**Institute of  
Hydrology**

**Review of a proposed  
Water Management Plan,  
Pickeridge Farm Quarry,  
Fulmer, Bucks**

October 1995

**FIGURE 2**

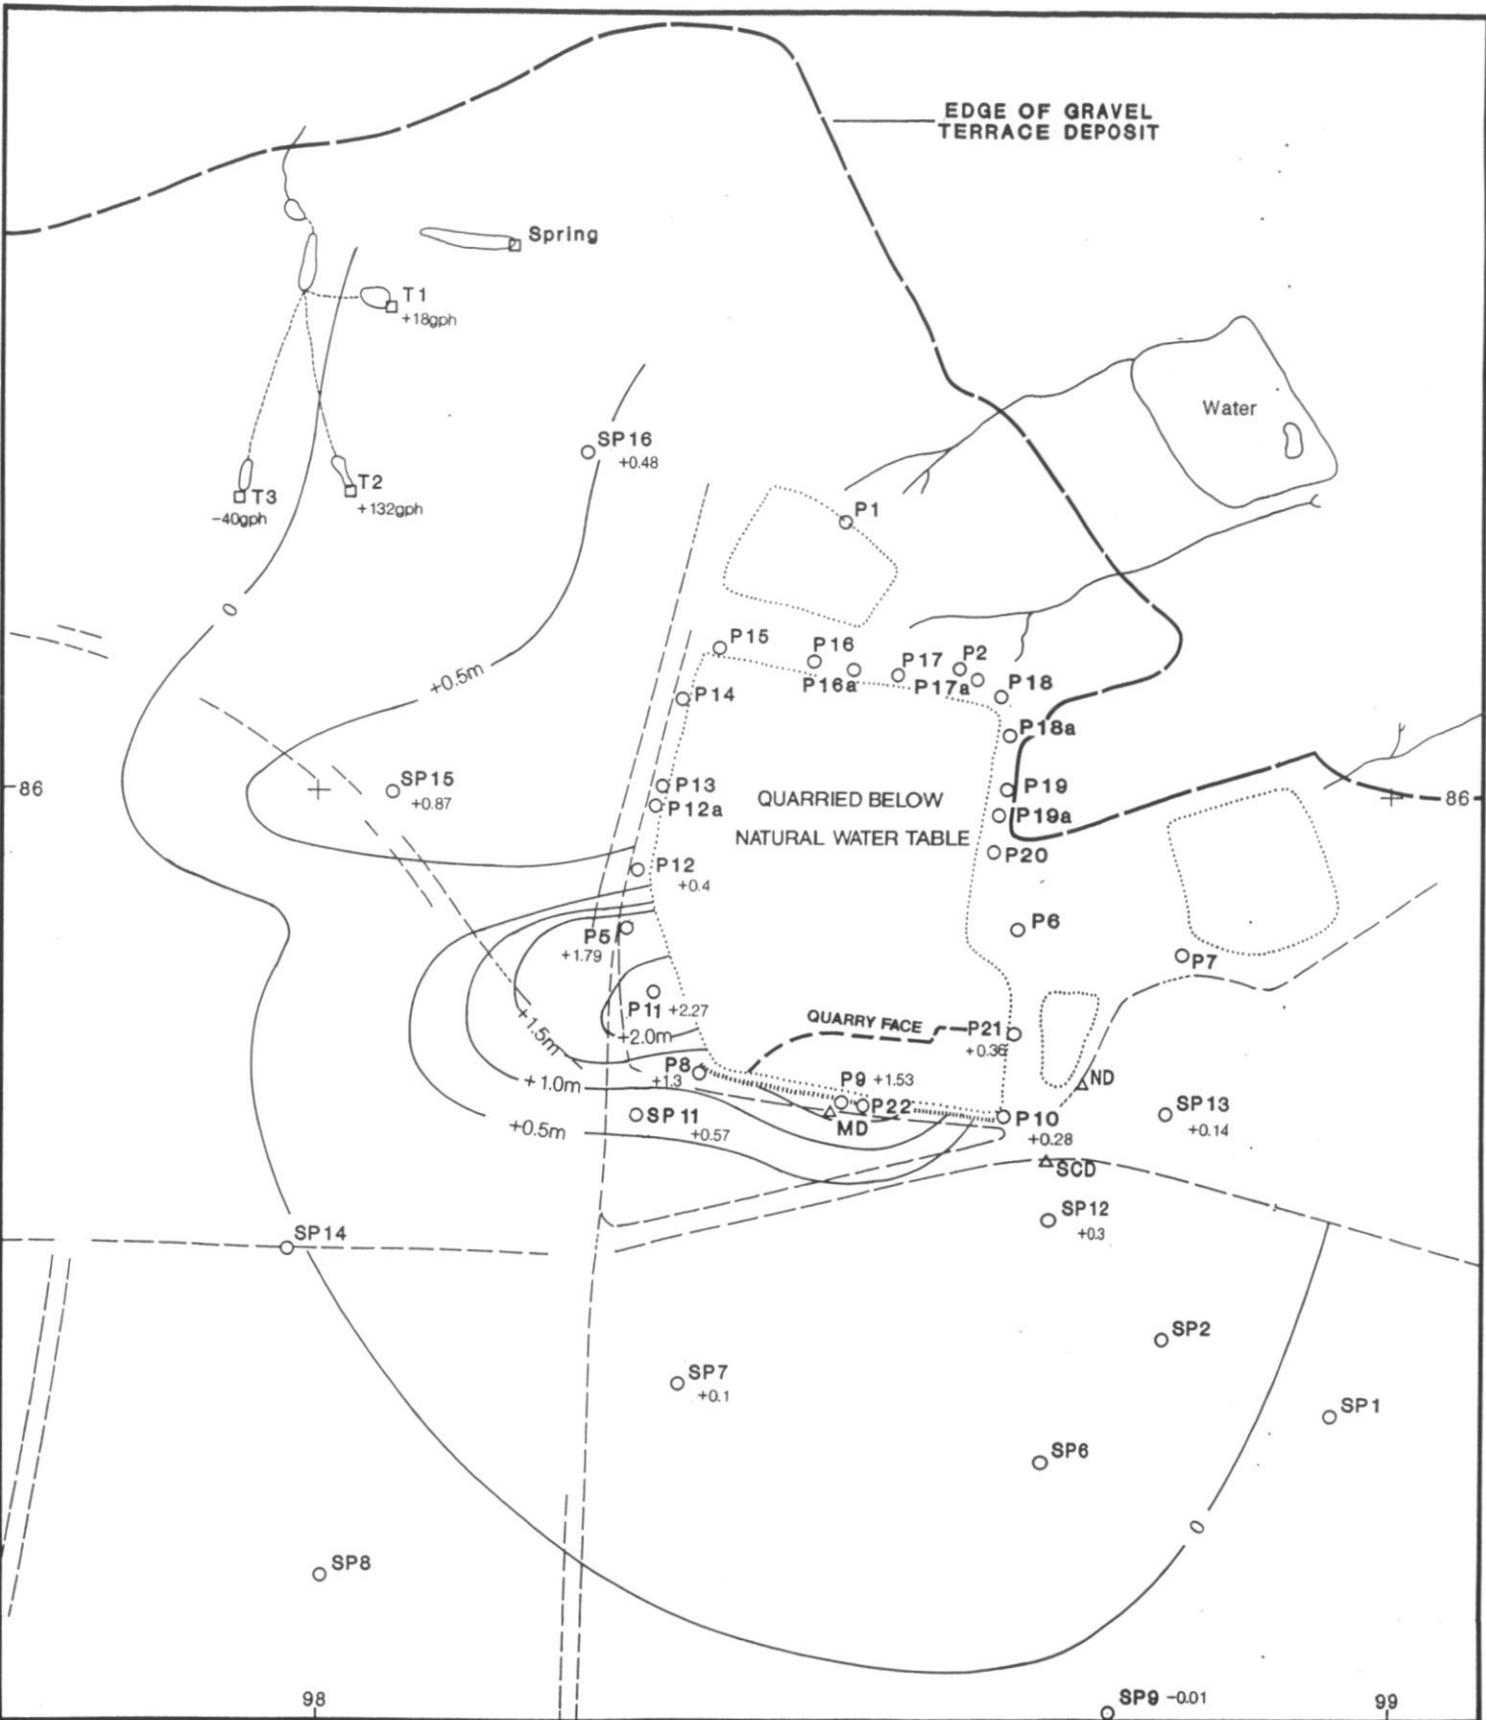
3.3.3 There is a risk that these channels could take away from the immediate area water

which should be recycled into the groundwater. The planned spur channels, and weir boards should be adequate to reduce this risk to acceptable levels. Any failure of the weir boards may require damming of the channels at a suitable distance from Cell 10 (say 100 metres to the east of P10).

The scale of the problem does not warrant detailed calculations of optimal heights for any weir boards. The height proposed in the Plan should be adequate, and may be adjusted if required.
